ACCESSION NBR:8308290378 DOC.DATE: 83/08/22 NOTARIZED: NO DOCKET #
FACIL:50-410 Nine Mile Point Nuclear Station, Unit 2, Niagara Moha 05000410
AUTH.NAME AUTHOR AFFILIATION
RHODE,G.K. Niagara Mohawk Power Corp.
RECIP.NAME RECIPIENT AFFILIATION
SCHWENCER,A. Licensing Branch 2

SUBJECT: Requests approval of alternative method of meeting Reg Guide 1.63 guidelines re installation of containment electrical penetrations.Electrical penetration assemblies bolted to liner nozzles as shown on encl figures.

NIAGARA MOHAWK POWER CORPORATION
NINE MILE POINT-UNIT 2
FINAL SAFETY ANALYSIS REPORT

ELECTRICAL PENETRATIONS
MEDIUM VOLTAGE (TYPICAL)
SHEET 1 OF 2

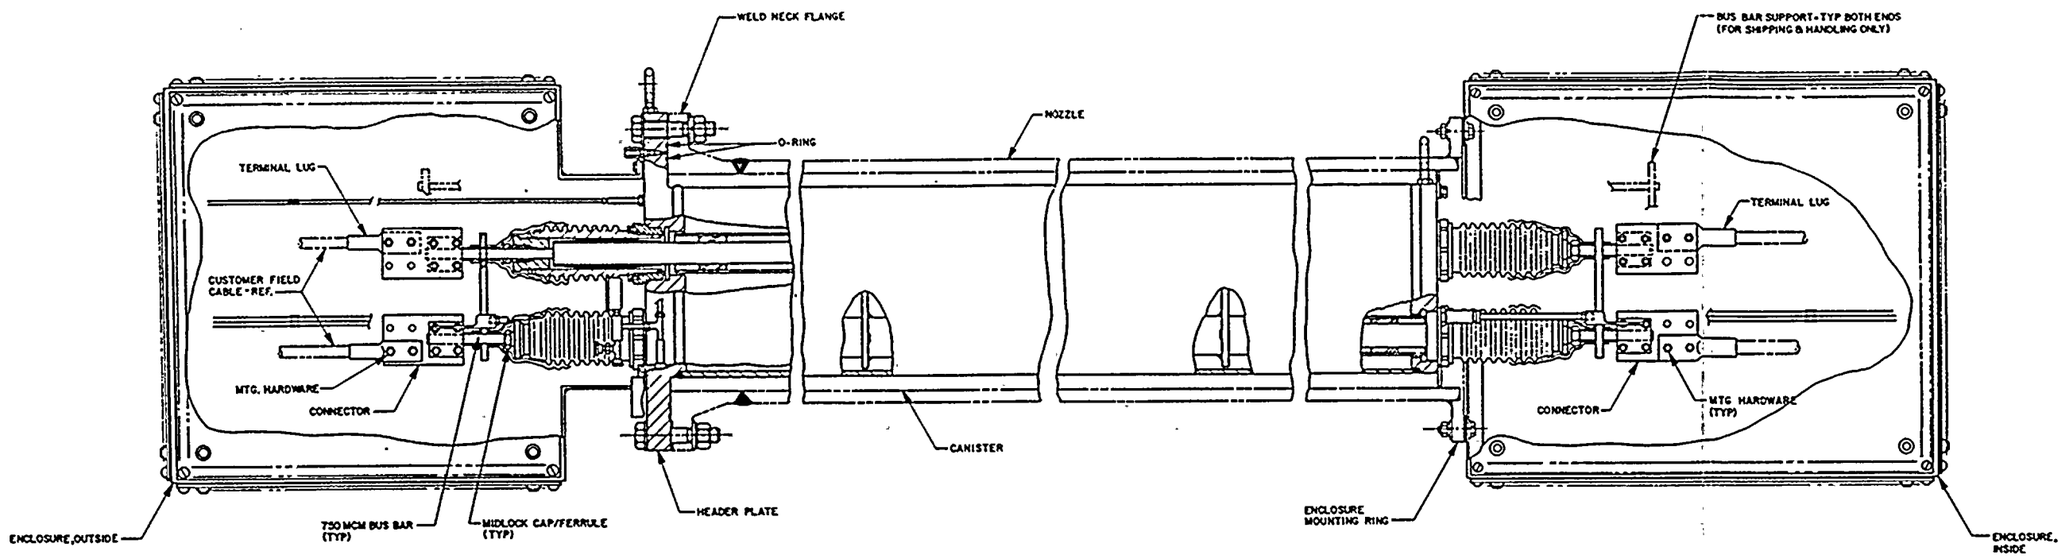
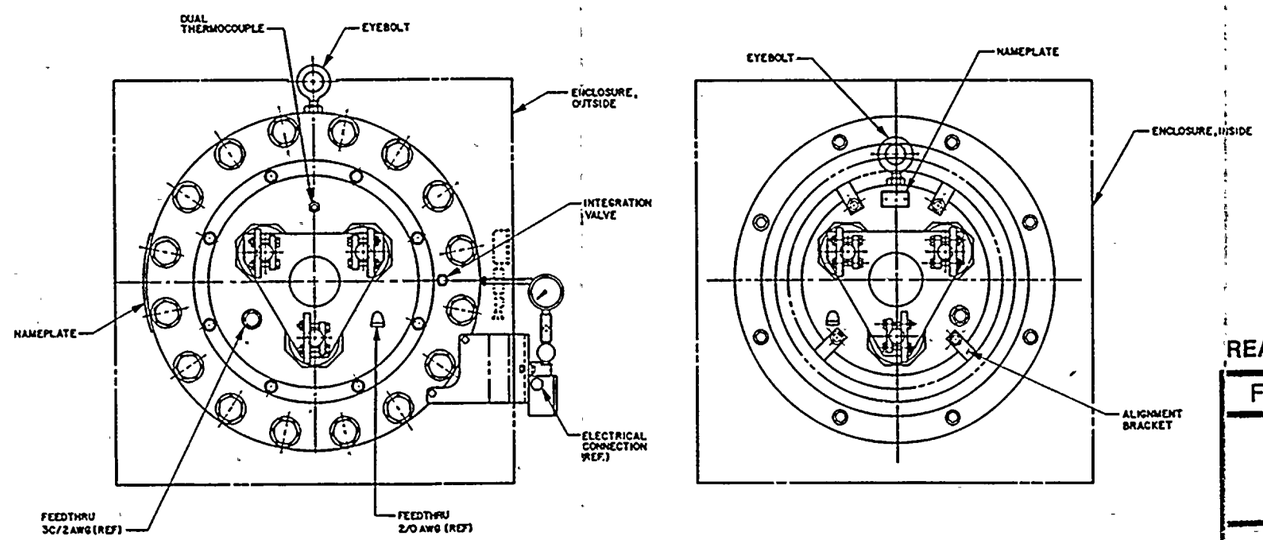
For Nine Mile Point-Unit 2, the installation of electrical penetrations would be performed under the Stone & Webster Engineering Corporation Quality Assurance Program for Category I components. The electrical penetration assemblies are bolted to the liner nozzles as shown on the attached figure. Due to the dates of order and fabrication, the liner nozzles were not required to be "N" stamped. Therefore, an ASME III program for installing these electrical penetrations is not warranted since the containment to which the penetrations will be bolted is not an N-stamped component. Installation based on the manufacturer's recommendations, in process surveillance, final visual inspection and leak rate testing performed in conformance to the Stone & Webster Engineering Corporation Quality Assurance Program will provide a high degree of assurance appropriate for the penetrations.
